Addendum #2

Date: April 24, 2015
Project: Baker Annex Two-Story Addition
Contract: FD-14-009

TETRA TECH www.tetrattech.com 240 Continental Drive, Suite 200 Newark, DE 19713 302.738.7551	DELAWARE STATE UNIVERSITY, DOVER, DE 19901	REFERENCED SHEET: A-601 Project No.: 200-98424-14001
	DSU PROJECT #FD-14-009 BAKER ANNEX 2 STORY ADDITION/COURTYARD	Date: 04-24-2015 Designed By: MJS
JAMB DETAIL		Supplemental Type SK-A-01

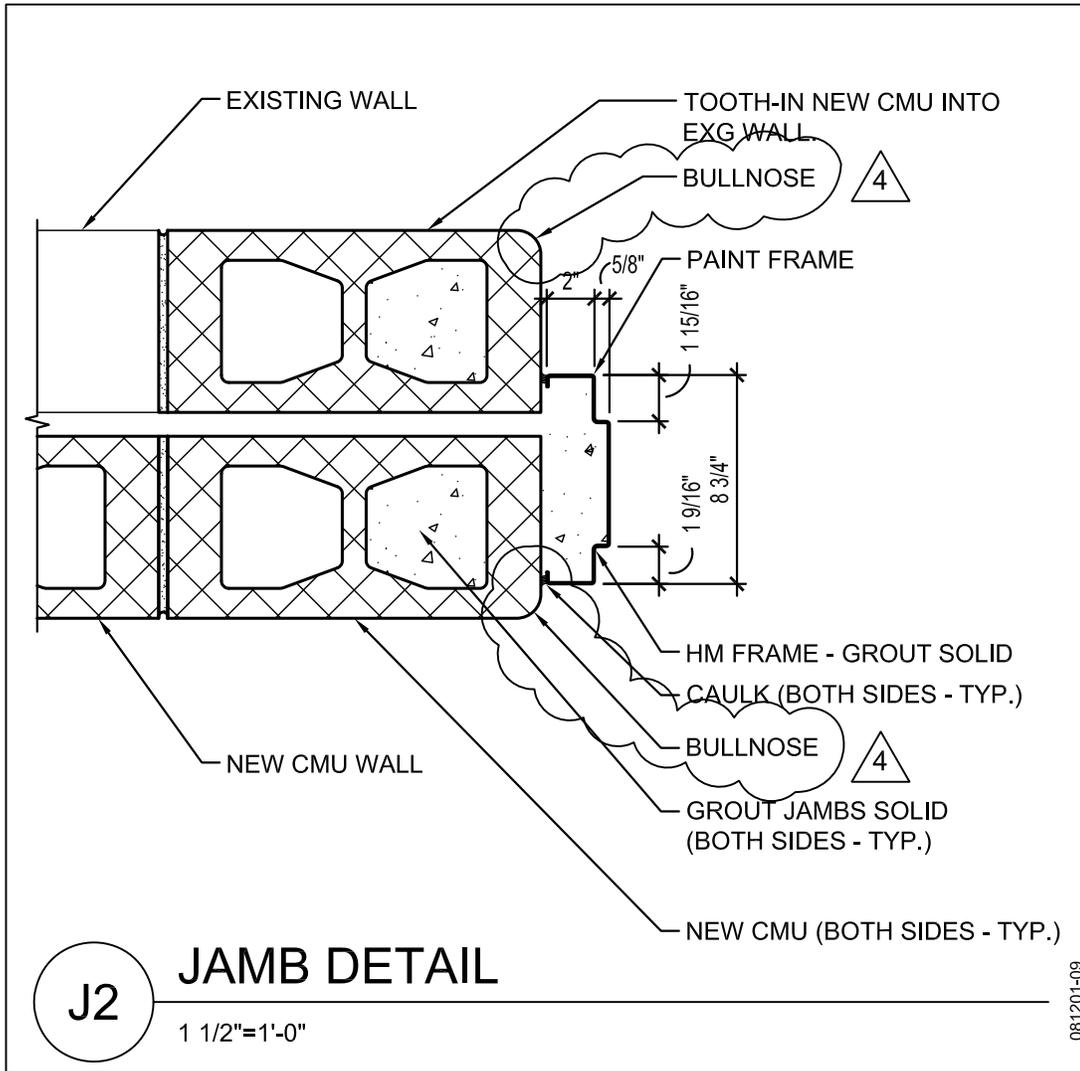
1. See attached Sheet A-601, Detail J2.

- 6. Question:** Please see the following RFI: Spec Section 042000 Unit Masonry references outside corners as square edged. During our walkthrough we noted window jambs, and outside corners as bullnosed. Please confirm if bullnosed block is to be utilized on the project and clarify at what location.

Answer: Spec Section and Drawings will be revised to show 'Bullnosed' in lieu of 'Square Edged' at all outside corners. Detail J2/A-601 will be revised to show a bullnosed block at outside corners.
